PST MOUNTS

MONTH MAY, 2002

PHONE MEETING

Proposal for SCT - Pixel Interface

SCT - PIXEL
INTERFACE

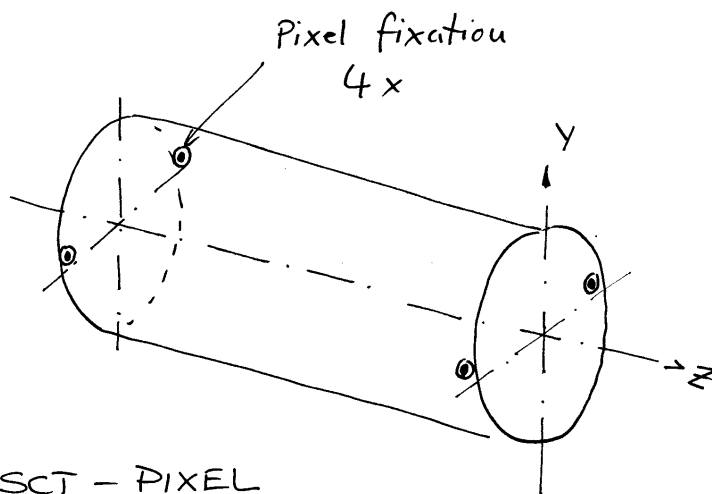
- 4 Blocks fastened to the SCT horizontal interlinks
- Adjustment, if needed, by shimming or machining spl. blocks

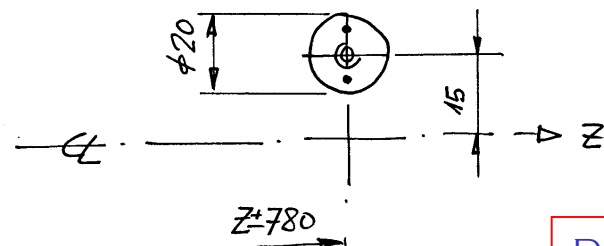
DIMENSION
IS OK

SCT Inner thermal enclosure

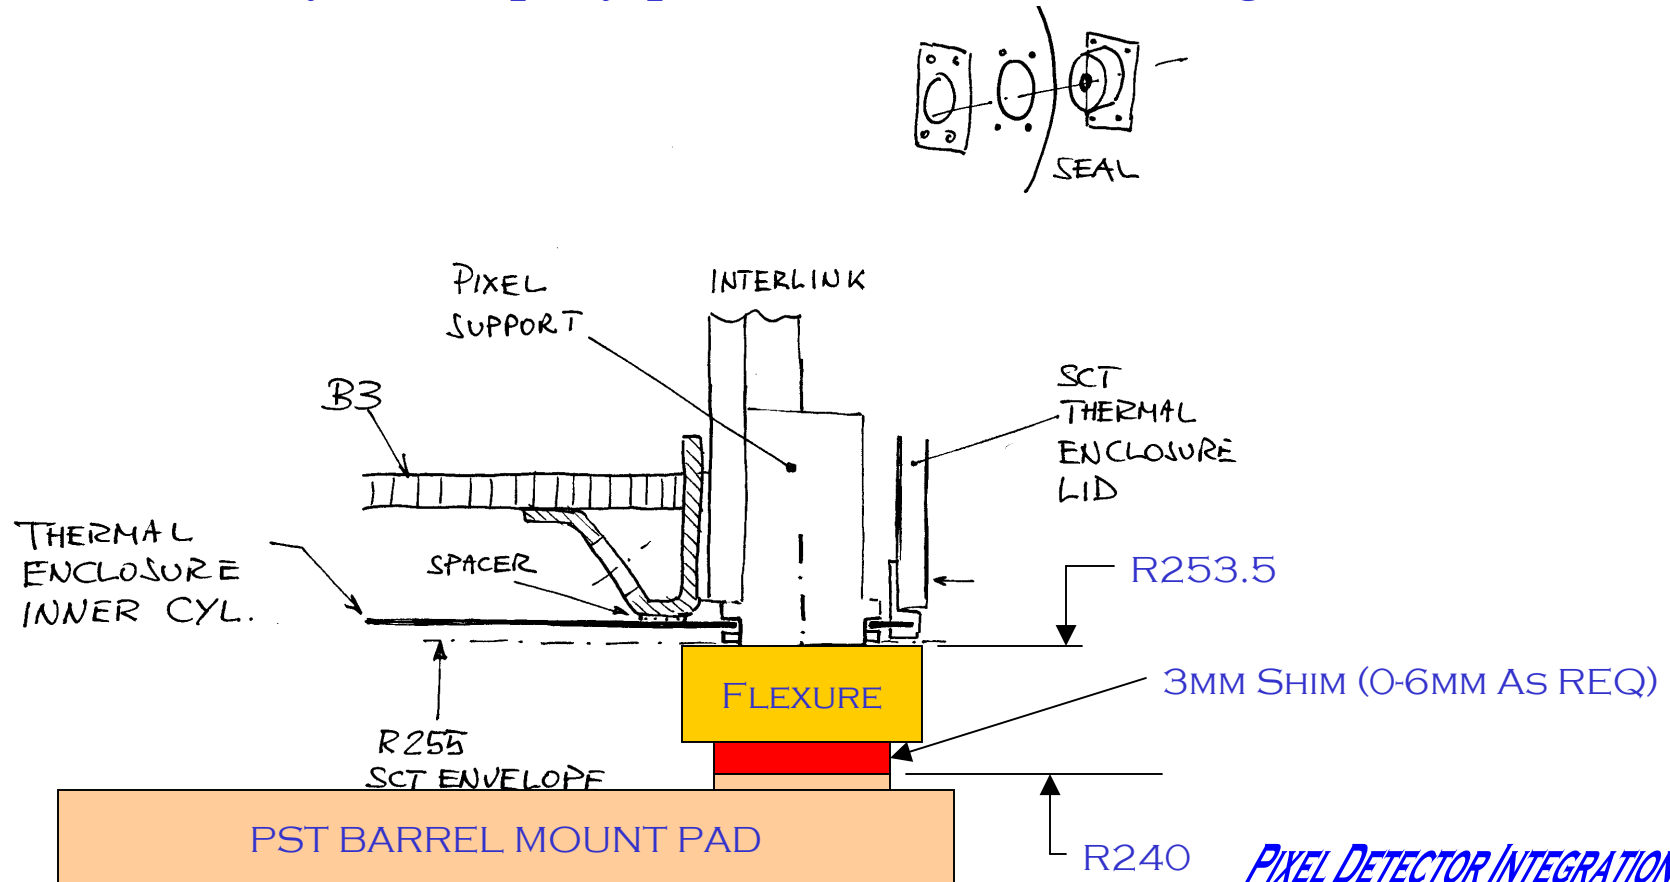
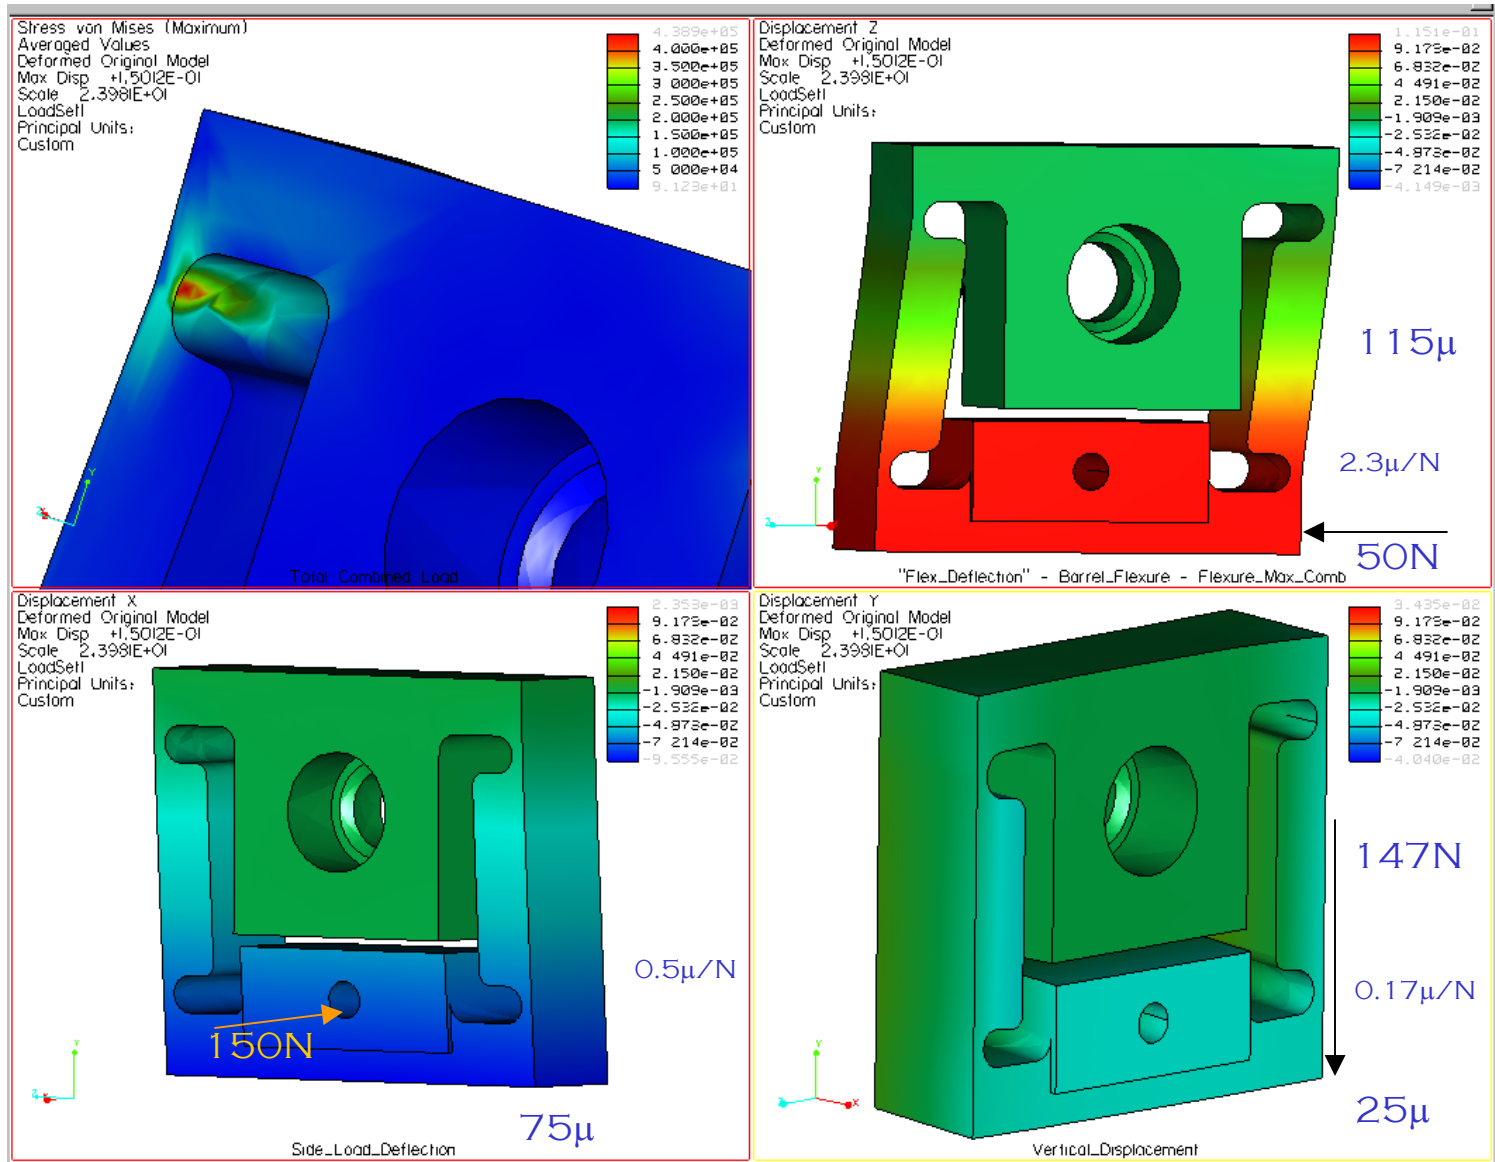
- I propose to fix the TE inner cylinder directly to Barrel 3
 - To save space.
 - To try to simplify penetrations and sealing.
